LIGO-T1000182-v1

ECO for the GS-13 Socket Boards D0902011 rev. v3

The purpose of this form is to document the changes that should be performed on a GS-13 Socket Board whose version on the PCB is D0902011-v3.

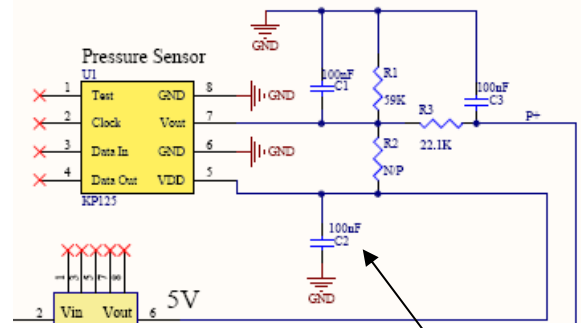
The only change to this board is that capacitor C2 should be moved so that the incoming voltage reference is shunted directly to ground, instead of being shunted to the Pressure output. Here's the original schematic:

C2 should be moved from here...

...to here.

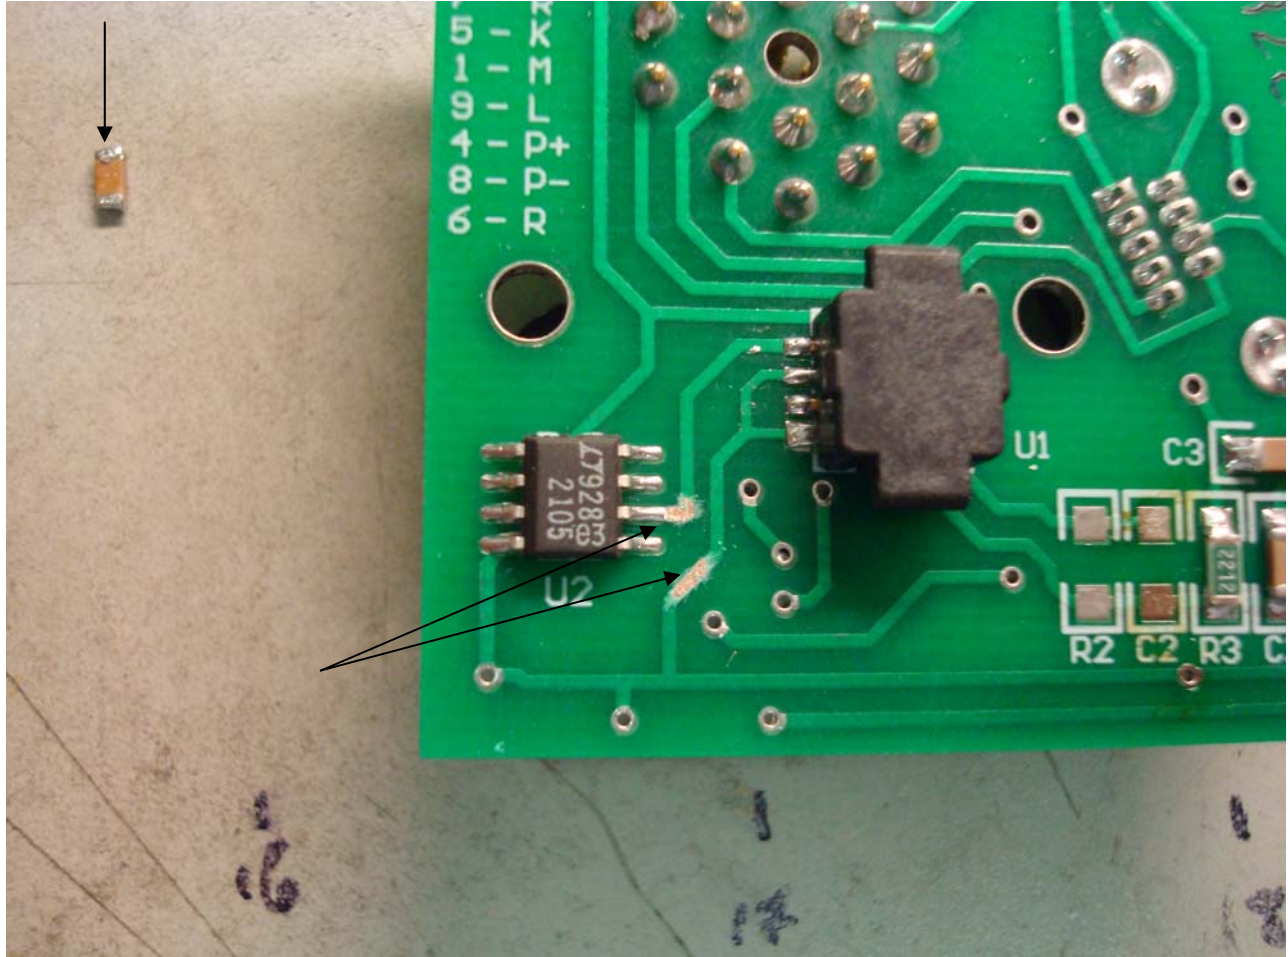
Here, C2 (on the left of the picture) has been removed from its original position, and the two traces near U2 have been carefully scraped to remove the solder mask...

Care should be exercised to not scrape all the way through the copper traces.

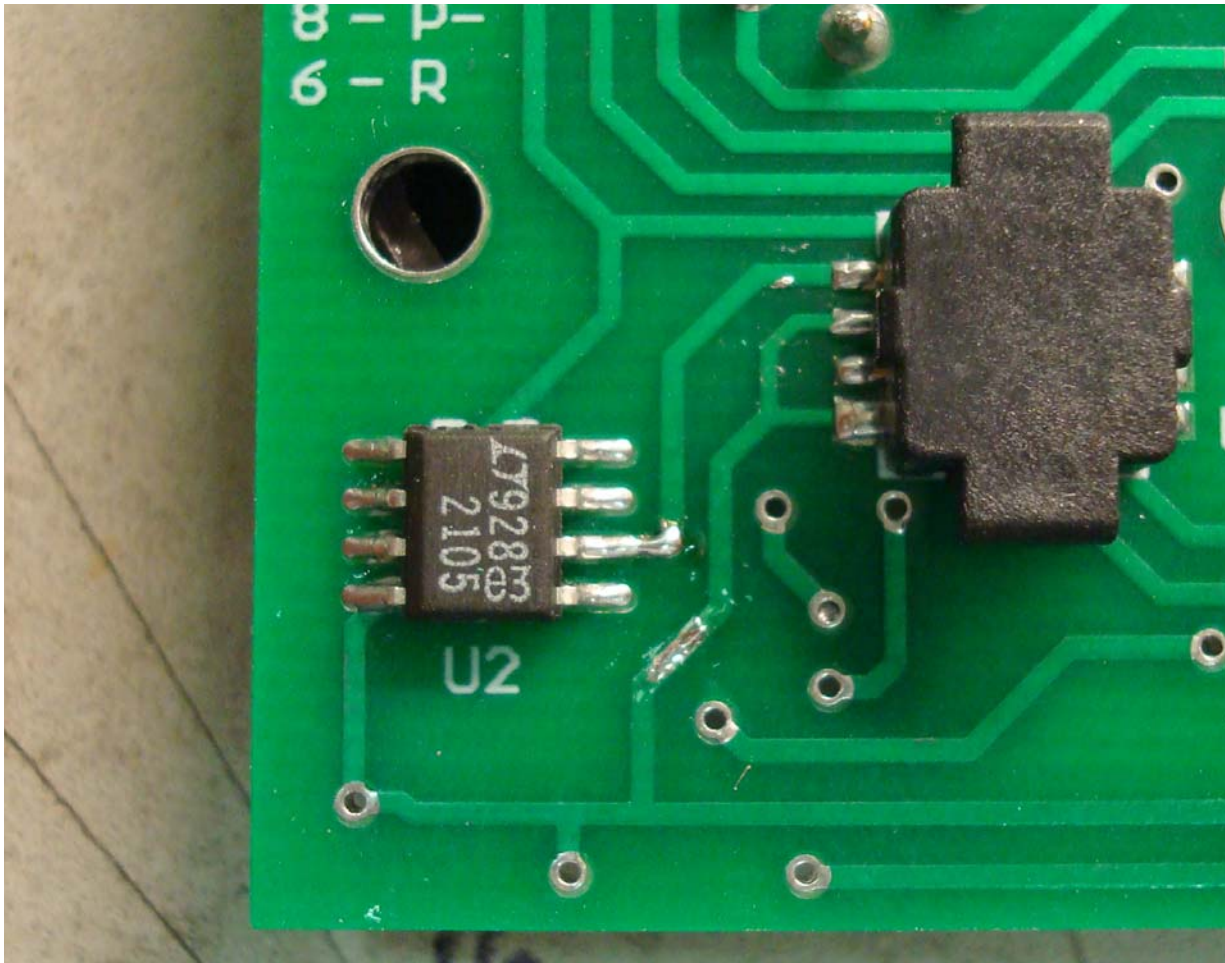
The two traces are lightly tinned, to ensure their cleanliness (tinning will not stick to dirty traces, or ones that still have soldermask on them)...

Then C2 is placed, straddling the gap, being sure to make the solder joints neat and secure, and that they haven't shorted anything.
